Subject: MHI's Responses to US-APWR DCD RAI 408-3170 Revision 0

Reference: 1) "REQUEST FOR ADDITIONAL INFORMATION 408-3170 REVISION 0, SRP
Section: 10.04.09 - Auxiliary Feedwater System, Application Section: 10.4.9,
dated June 24, 2009.

Responses to Request for Additional Information No. 408-3170
Revision 0

RAI NO.: NO. 408-3170 REVISION 0
SRP SECTION: 10.04.09 AUXILIARY FEEDWATER SYSTEM
APPLICATION SECTION: 10.4.9
DATE OF RAI ISSUE: 6/24/2009

The Tier 1 DCD, Figure 2.7.1.11-2 will be revised as shown below:

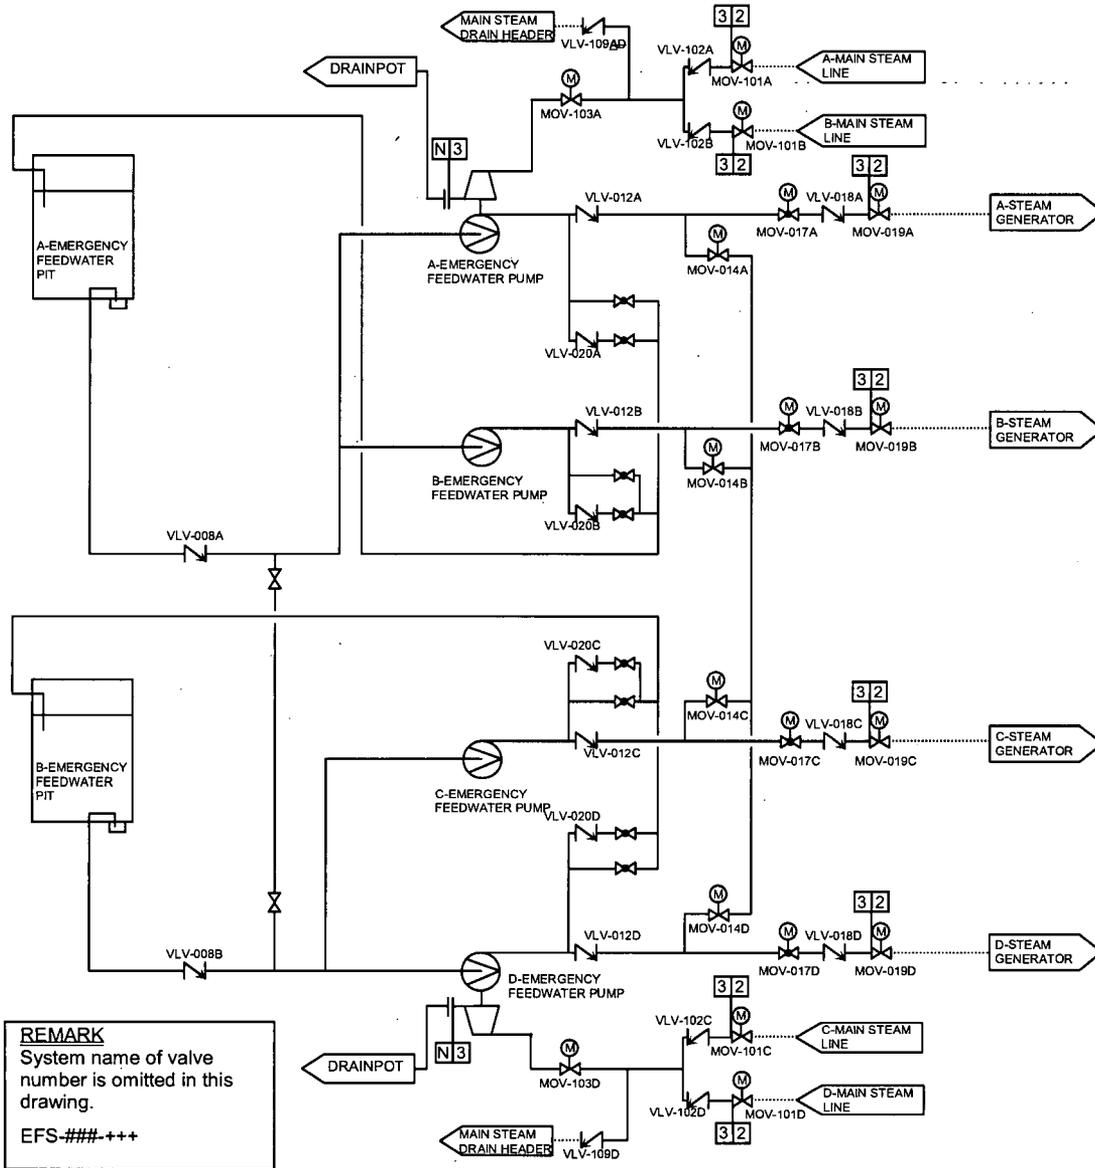
[Followup/Supplementary RAI 10.4.9-7] In response to request for information (RAI) Question No. 10.04.09-20 issued 1-21-09, the applicant stated that revisions will be made to Design Control Document (DCD) Tier 1 to include check valves with an active safety function. The portions of the DCD Tier 1 to be revised to include Figure 2.7.1.11-1, "Emergency Feedwater System." The staff noted an apparent typographical error in the applicant's proposed revision to DCD Tier 1, Figure 2.7.1.11-1 with regard to the numbering of the check valves. In particular, what would appear to be check valve "VLV-109A" seems to be incorrectly labeled as check valve "VLV-109D."

Verify whether the check valve is correctly labeled, and correct the proposed revision to DCD Tier 1, Figure 2.7.1.11-1 with regard to the mis-labeling of check valve "VLV-109A" if necessary. Include any revised information in the DCD and provide a markup in your response.

A check valve in DCD Tier 1 Figure 2.7.1.11-2, "Emergency Feedwater System" is incorrectly labeled and the figure will be revised as shown in Impact on DCD.
